Exhibit I
Response to Comments
on the Tower District Specific Plan and
Tower District Design Standards and Guidelines
(comments received August 15, 2025 to September 29, 2025)

**COMMENT SUMMARY MATRIX for the PUBLIC REVIEW DRAFT TOWER DISTRICT SPECIFIC PLAN (AUGUST 2025)
and the PUBLIC REVIEW DRAFT TOWER DISTRICT DESIGN STANDARDS AND GUIDELINES (AUGUST 2025)**

FIGURE 3.2 | Planned Land Use

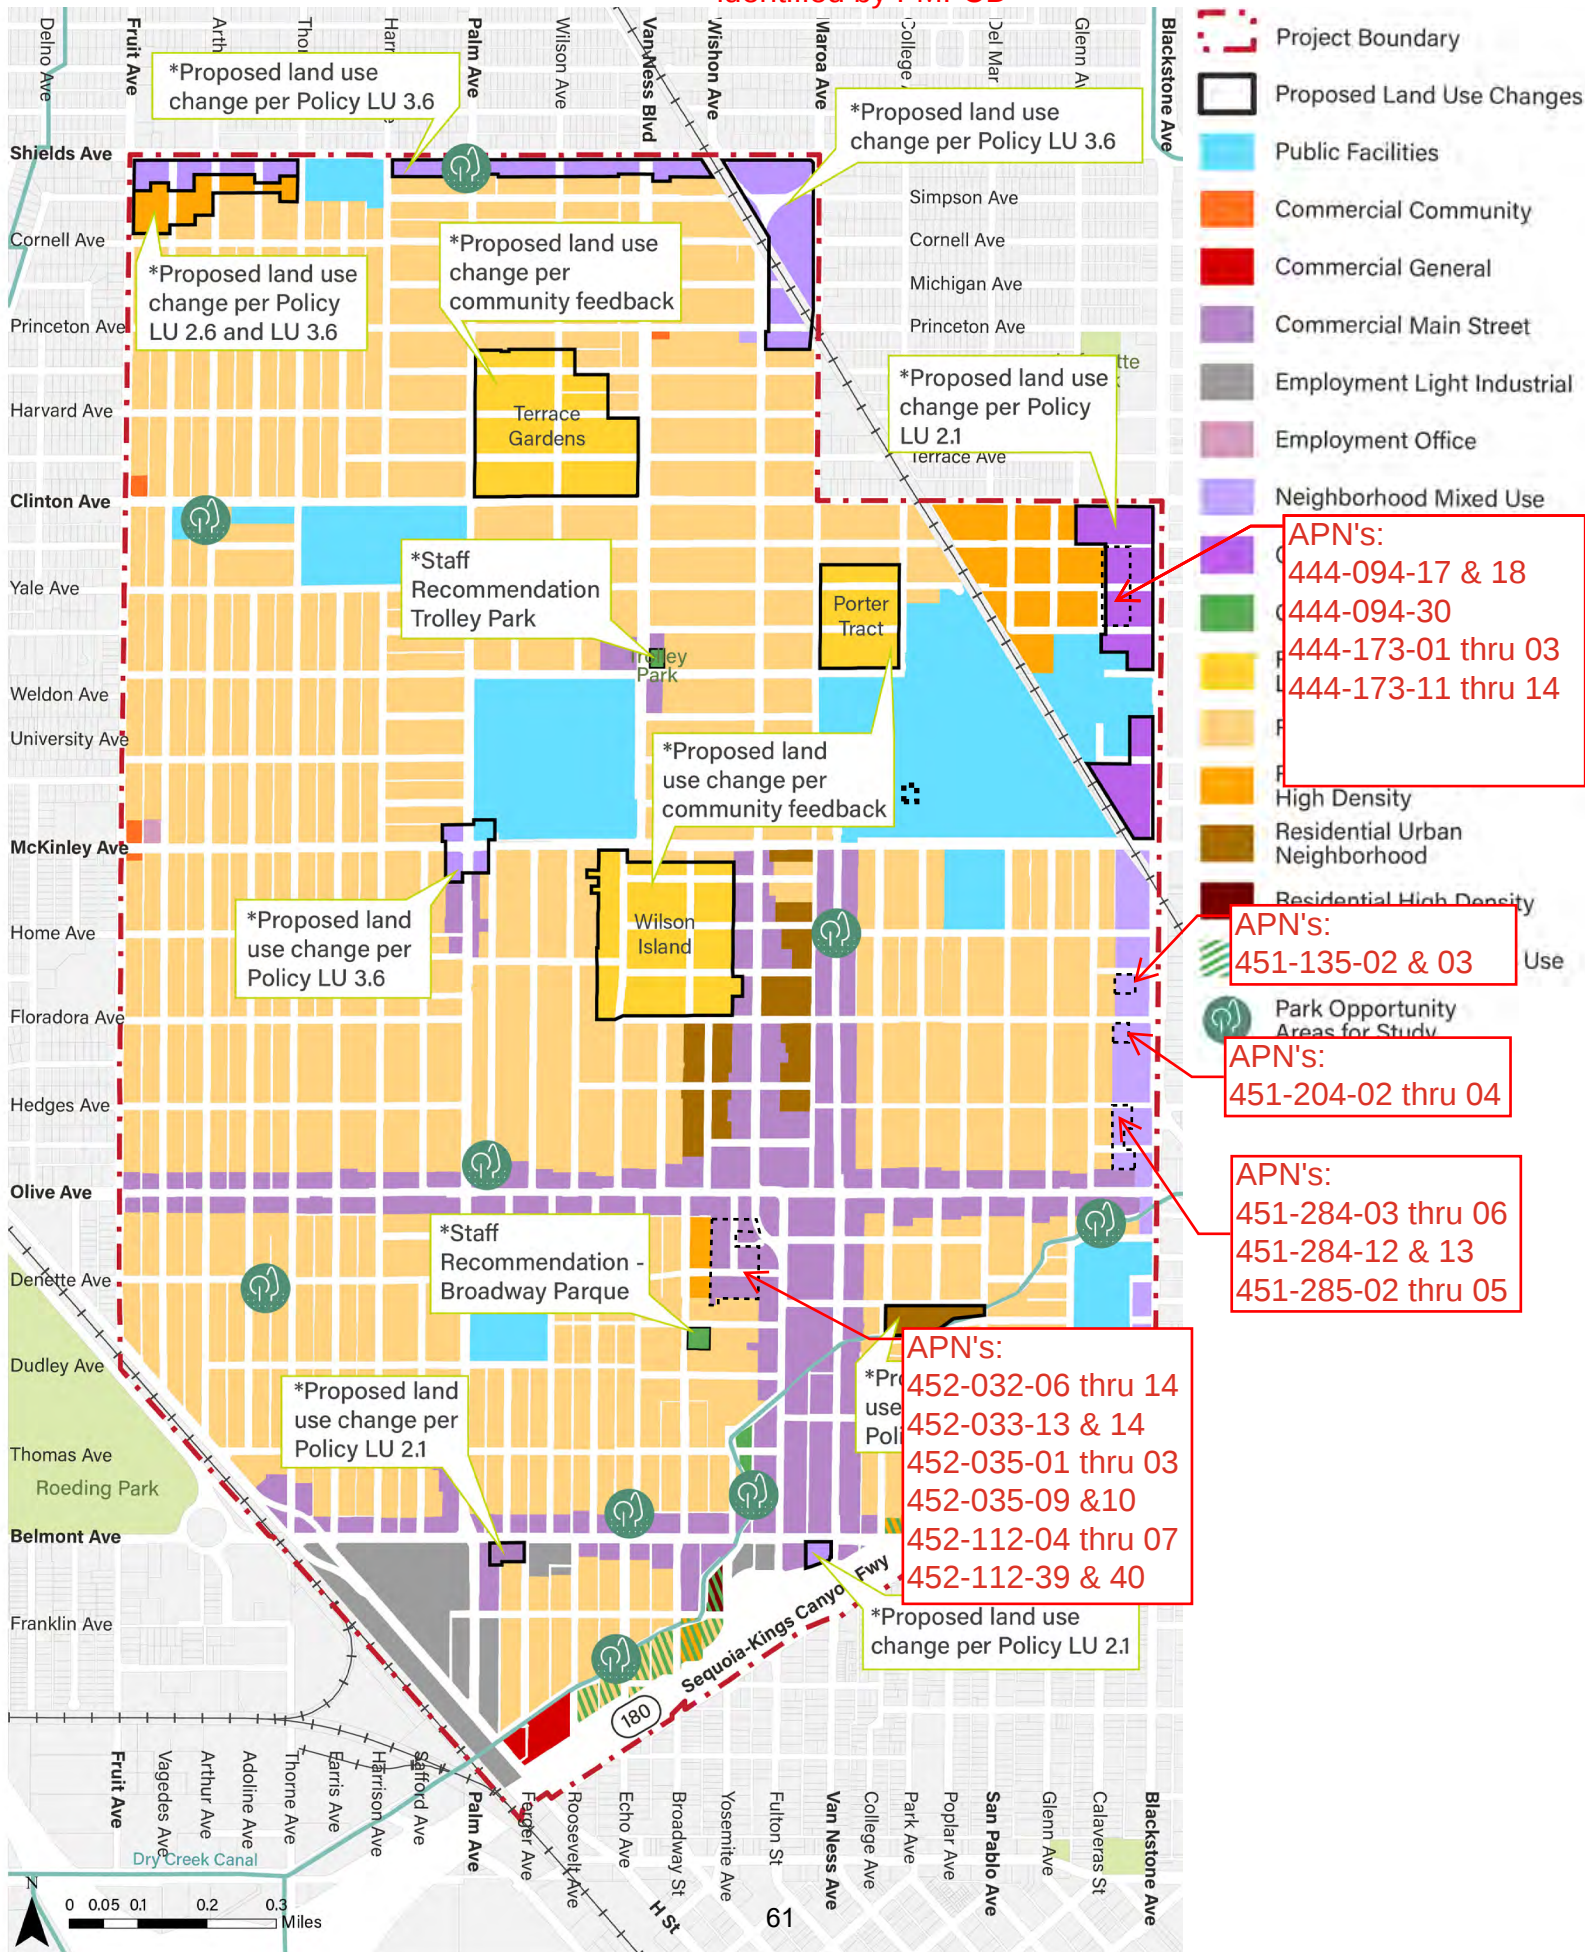
For areas that have existing drainage facilities and propose changes to land uses that generate more runoff than originally planned, some type of mitigation to accommodate the increased flow such as parallel pipes and/or on-site retention may be required. FMFCD has identified properties within the Plan Area that may require some form of mitigation as noted on attached Figure 3.2 from the subject Tower District Specific Plan Update.

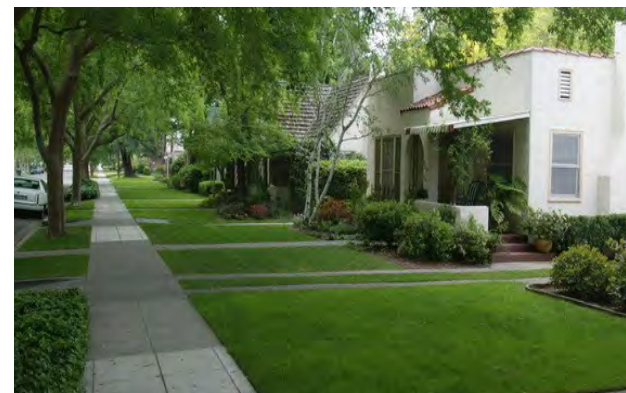
Diagram for this?
